Access Compliance Report

Public Rights-of-Way

(Curb Ramps)

Intersection ID: 4562	Main Street: MALLARD_CREEK_RD	Cross Street: SUMMERCROFT_LN	Location: SW
ADA ID: D79C7FC9AB90	Ramp Type: MedianPerp	Initial Pass/Fail: Fail	Overall Compliance: No
		Severity Score: 25

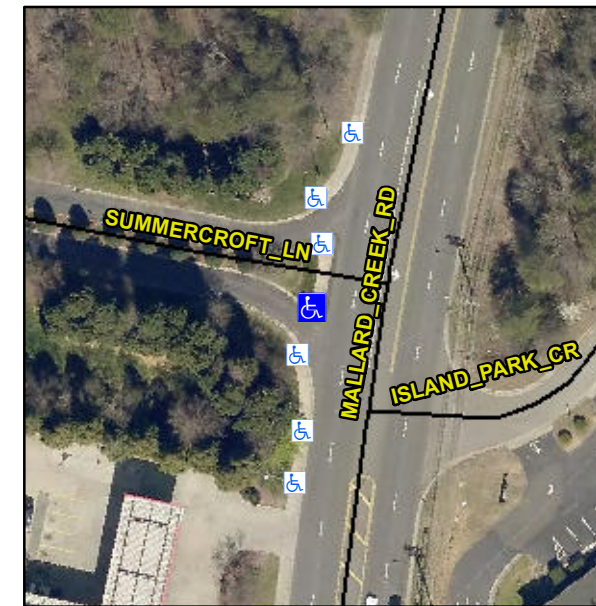
Not Found, R304.2.2, R304.5.3

Compliance	Description	Data	Compliance	Description	Data
N/A	Ramp Length (in)	43.0	No	Ramp Slope (%)	9.9
Yes	Ramp Width (in)	48.0	No	Ramp XSlope (%)	6.8
N/A	Flare Type LT	N/A	N/A	Flare Type RT	N/A
N/A	Flare Slope LT (%)	N/A	N/A	Flare Slope RT (%)	N/A
N/A	Flare Traversable LT?	N/A	N/A	Flare Traversable RT?	N/A
N/A	Landing Length (in)	N/A	N/A	DWS Provided?	N/A
N/A	Landing Width (in)	N/A	N/A	DWS Contrast?	N/A
N/A	Landing Slope (%)	N/A	N/A	DWS Length (in)	N/A
N/A	Landing X Slope (%)	N/A	N/A	DWS Full Width?	N/A
N/A	Landing Curb? (Y/N)	N/A	N/A	DWS Offset (in)	N/A
N/A	Shared Landing?	N/A			
N/A	Gutter Ponding?	N/A	N/A	Gutter Slope (%)	N/A
N/A	Gutter Lip Ht (in)	N/A	N/A	Gutter X Slope (%)	N/A
N/A	Painted X Walk1?	No	N/A	Painted X Walk2?	N/A
	X Walk 1 Direction	To S		X Walk 2 Direction	N/A
N/A	X Walk 1 Width (in)	N/A	N/A	X Walk 2 Width (in)	N/A
	X Walk 1 Slope (%)	8.0		X Walk 2 Slope (%)	N/A
	X Walk 1 X Slope (%)	0.8		X Walk 2 X Slope (%)	N/A

Remove & Replace Entire Ramp.
